**Denver Zoning Code Text Amendment**  
**Cherry Creek East Commercial Mixed Use Design Overlay District (DO-9)**  
**Cherry Creek East Residential Design Overlay District (DO-10)**  
**LUTI MEETING DRAFT - 12/15/2022**

Street Level and Upper Story Setbacks with Open Space Alternatives Design Overlay District (DO-9)

Front Porch and Landscaping Residential Design Overlay District (DO-10)

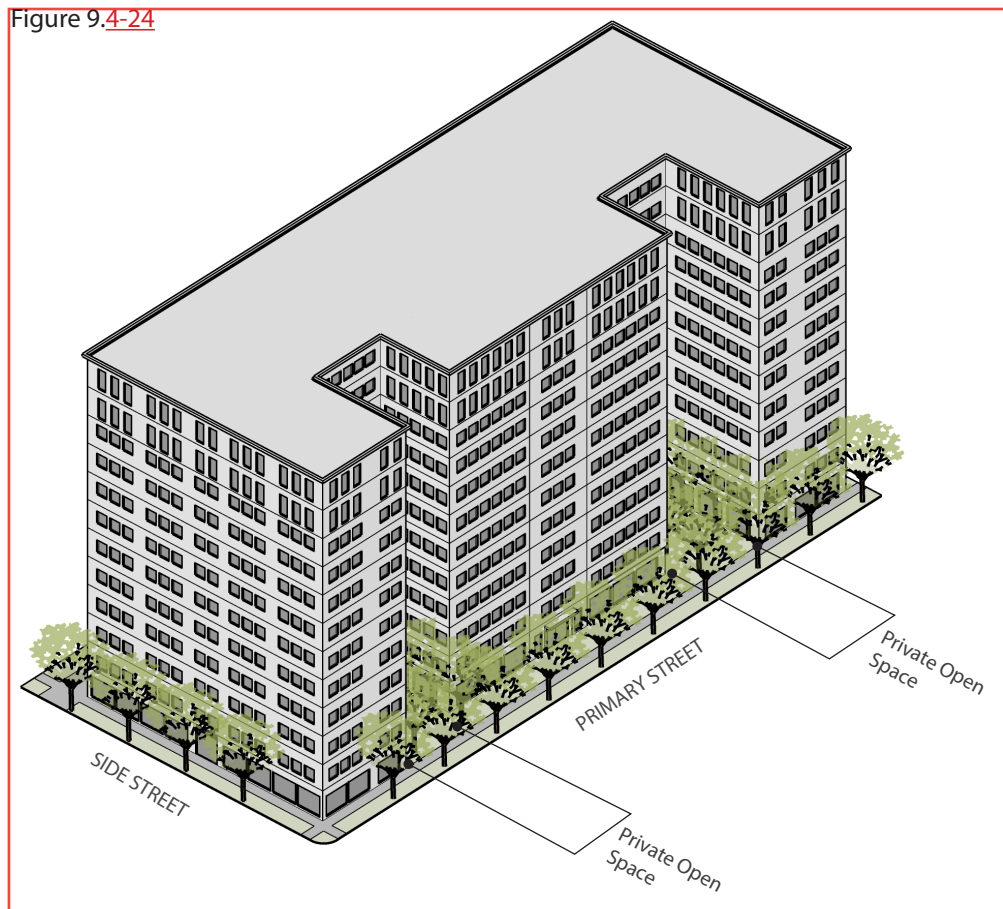
- i. Where a minimum 7 percent of the gross area of a Zone Lot is provided as Private Open Space meeting the rules of measurement set forth in Section 13.1.6.1.B, all Primary Structures on the Zone Lot shall not be required to meet the Street Level Primary and Side Street Setbacks. See Figure 9.4-24.

Figure 9.4-25

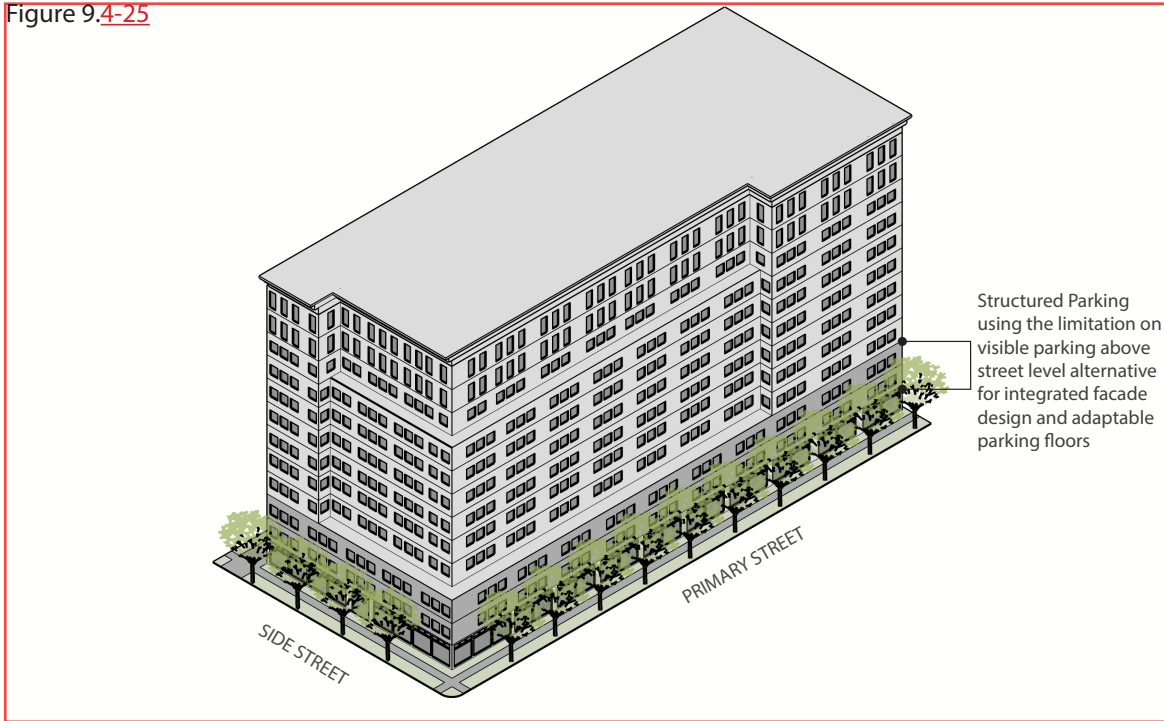
Where 100% of a street-facing building facade containing structured parking meets all the standards set forth in paragraphs i-iv below, the resulting integrated facade design and adaptable parking floors may be used as an alternative to the Limitation on Visible Parking Above Street Level in the DO-9 district. (See Figure 9.4-25)

i. Where the alternative is used, street-facing facades containing structured parking shall be integrated into the overall facade design through use of:

- a) Similar building materials to those used on adjacent facade areas that do not contain structured parking; and
- b) Facade articulation and fenestration patterns that integrate with portions of the building facade that do not contain structured parking.

ii. Where the alternative is used, street-facing facades containing structured parking shall minimize the visibility of parking areas through use of:

- a) Non-transparent facade materials for a minimum height of 4 feet from the finished floor of each story; and
- b) Fully-shielded LED or other lighting not exceeding 6,500 lumens behind a street-facing facade.

iii. Where the alternative is used, street-facing facades containing structured parking shall be designed with parking floors that are adaptable to other uses for a minimum depth of 30 feet from the Primary or Side Street-facing building facade through use of:

- a) A minimum 12-foot floor-to-floor height, measured from the upper surface of the floor to the upper surface of the floor or roof next above; and
- b) Floor plates that are level except to the minimum extent required for proper drainage; and
- c) Structures that are constructed to accommodate loads associated with office buildings per the International Building Code.

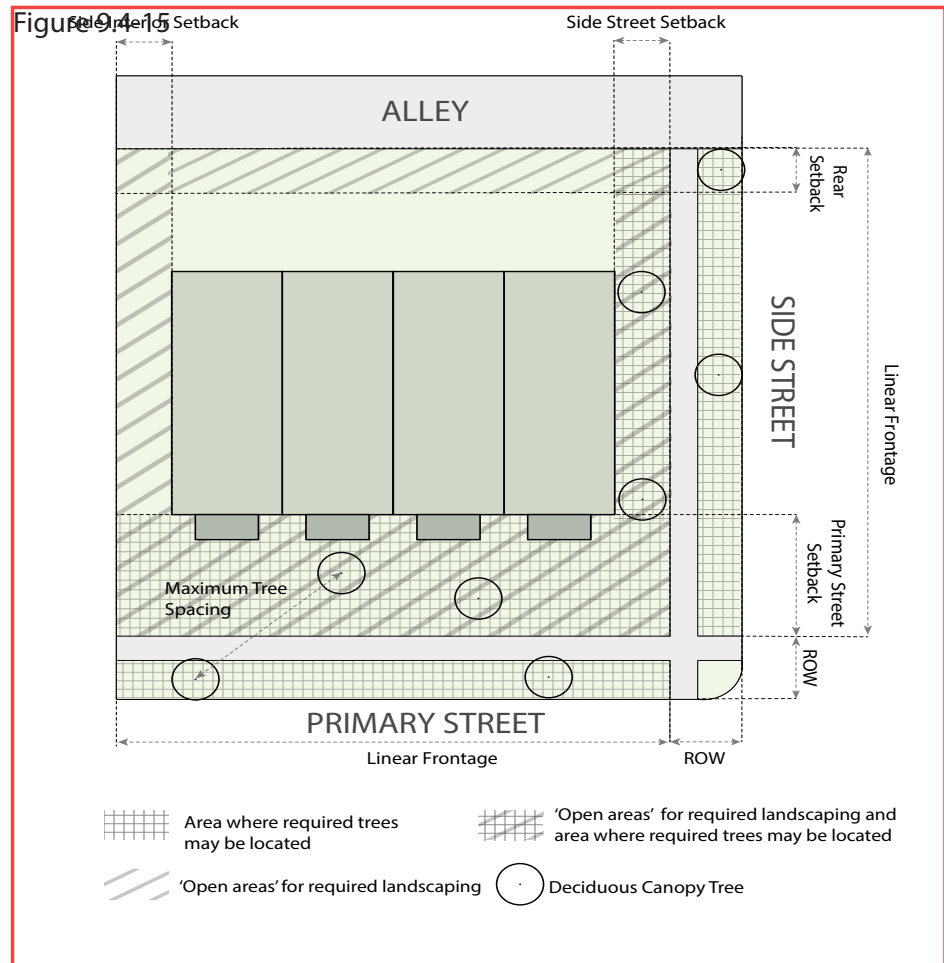
i. A minimum of 60% of the applicable "open areas" shall be landscaped with live planting material and the remaining 40% shall be landscaped with either live or non-live landscaping material, according to Section 10.5.4.6 Landscaping Material Standards. See Figure 9.4-15.

iii. On each Zone Lot, 1 deciduous canopy tree shall be planted for every 25' of linear frontage. Spacing of trees may vary, but the maximum spacing is 40'. See Figure 9.4-15.
